APPROVED
By Dan Naiman as Noted at 8:51 am, Oct 17, 2023

New Facility Entrance

Virginia Christensen
Multi-Use Facility

SUBMITTALS

4 RAMP HANDRAIL PLACEMENT
SCALE: 1/2" = 1'

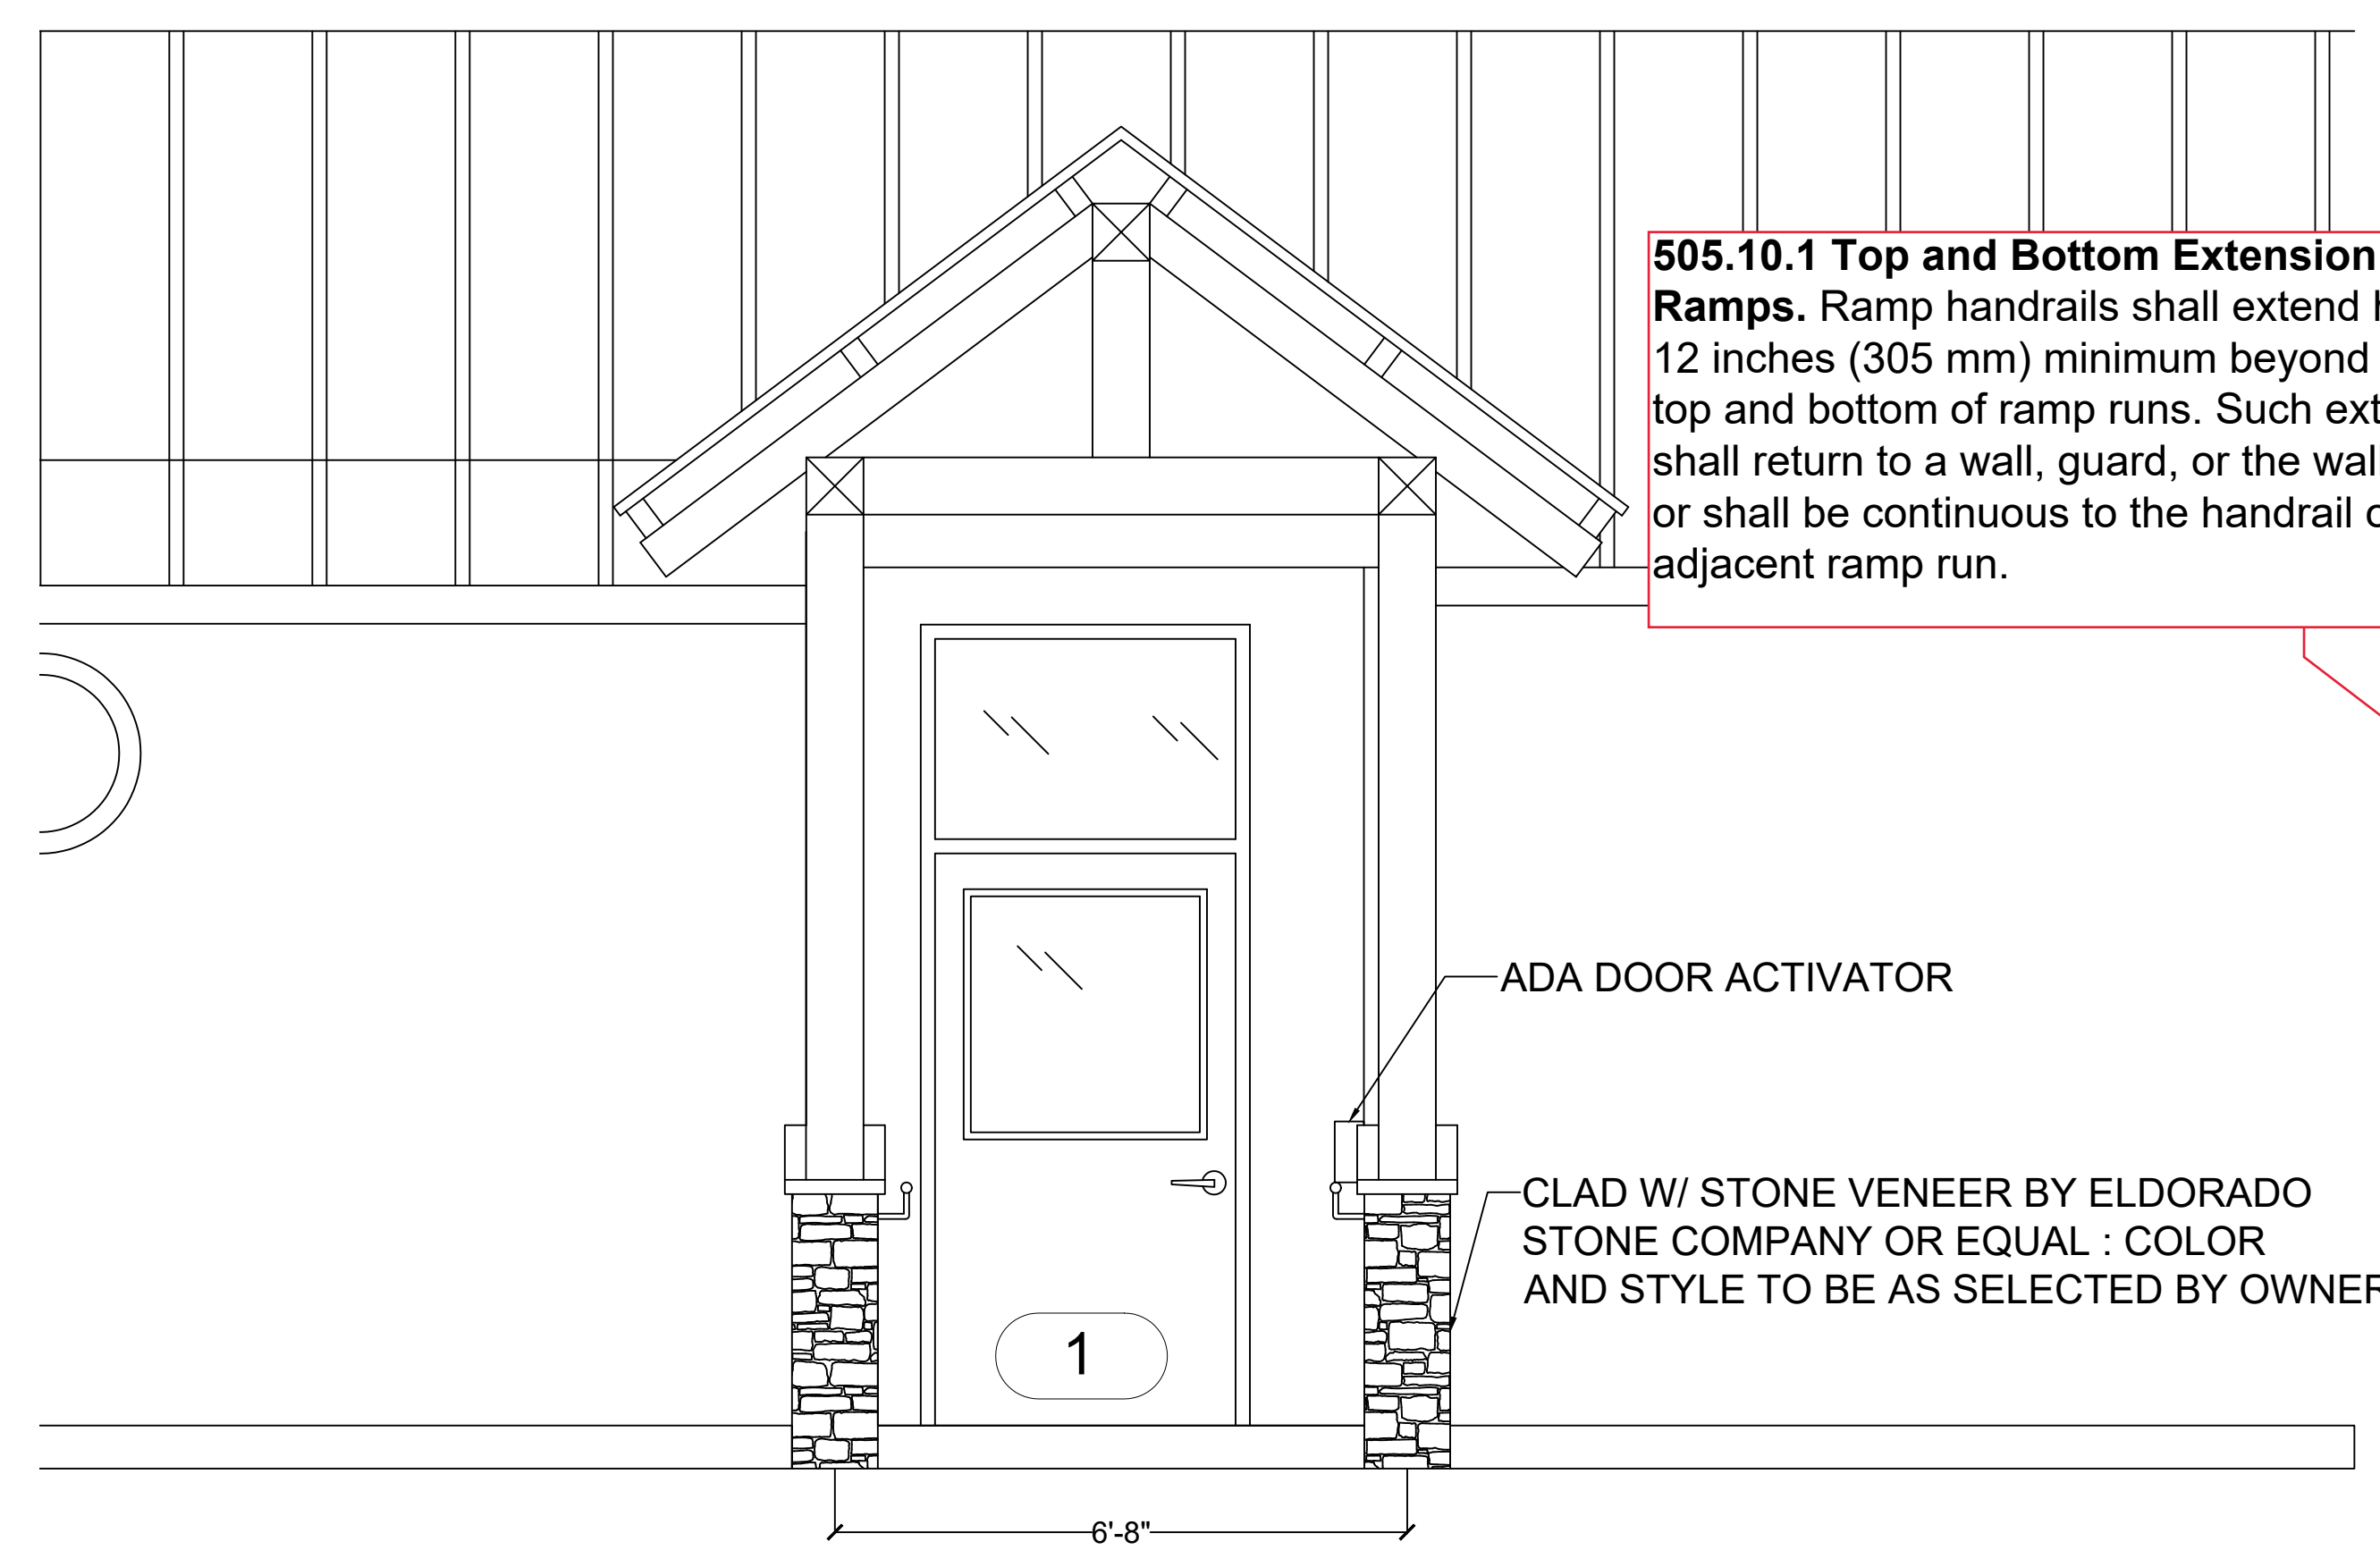
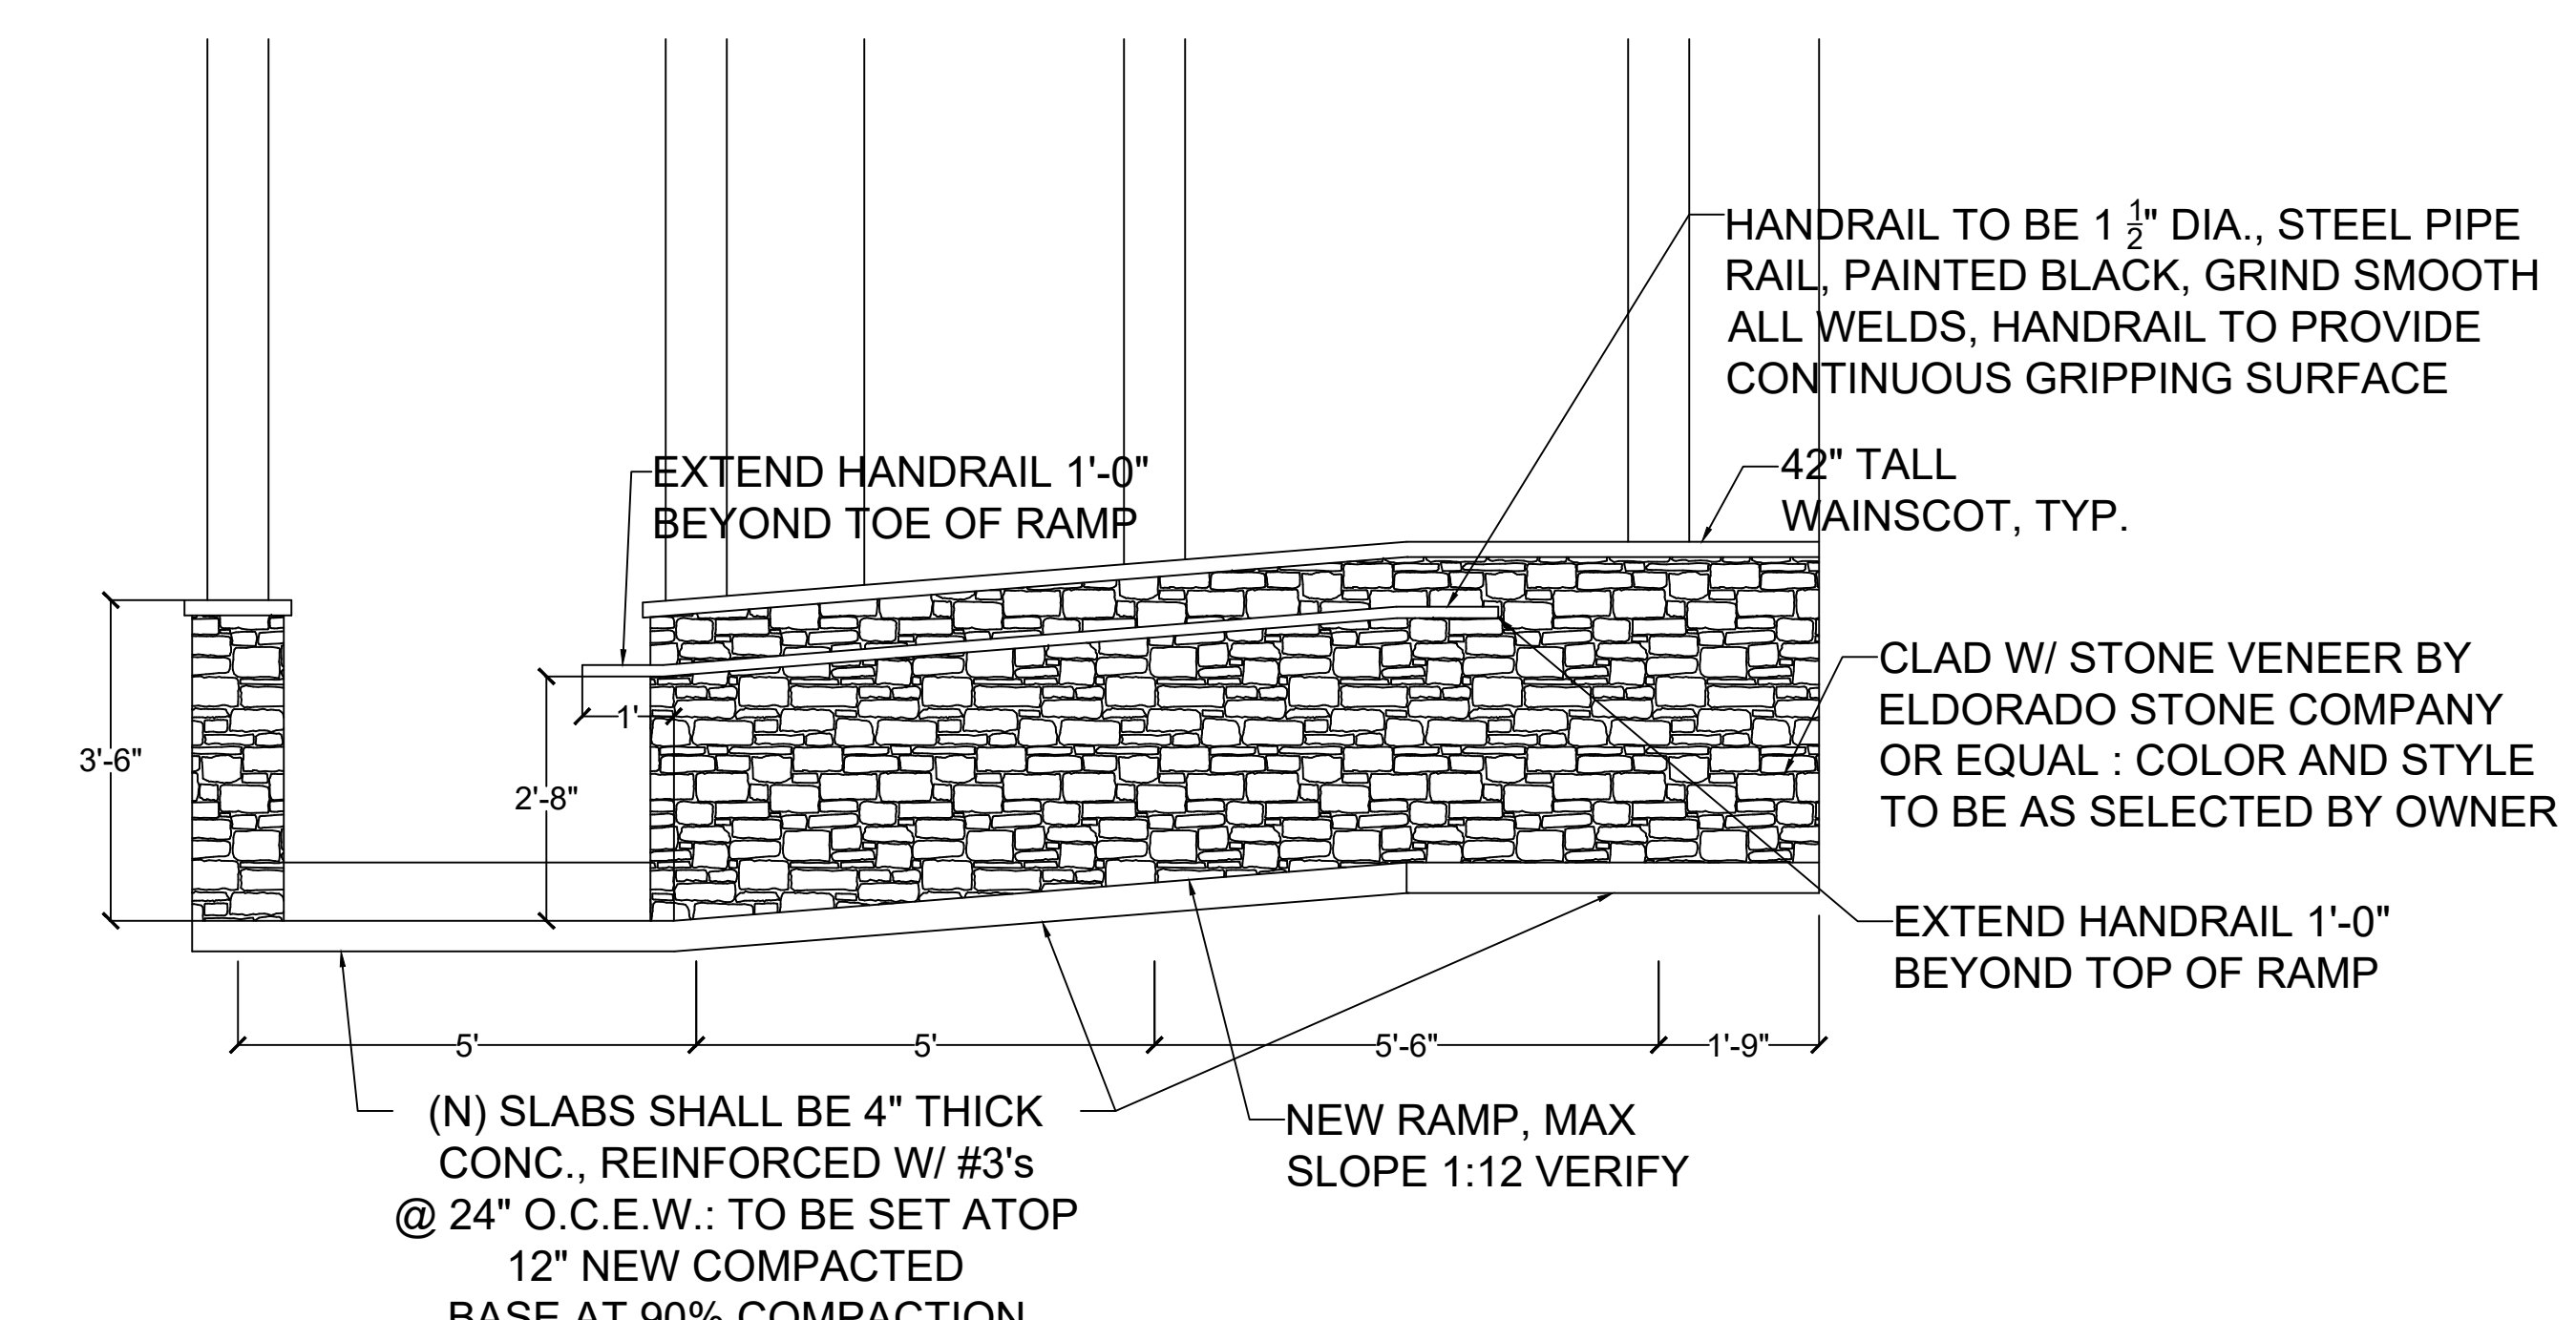
505.10.1 Top and Bottom Extension at Ramps. Ramp handrails shall extend horizontally 12 inches (305 mm) minimum beyond the top and bottom of ramp runs. Such extension shall return to a wall, guard, or the walking surface, or shall be continuous to the handrail of an adjacent ramp run.
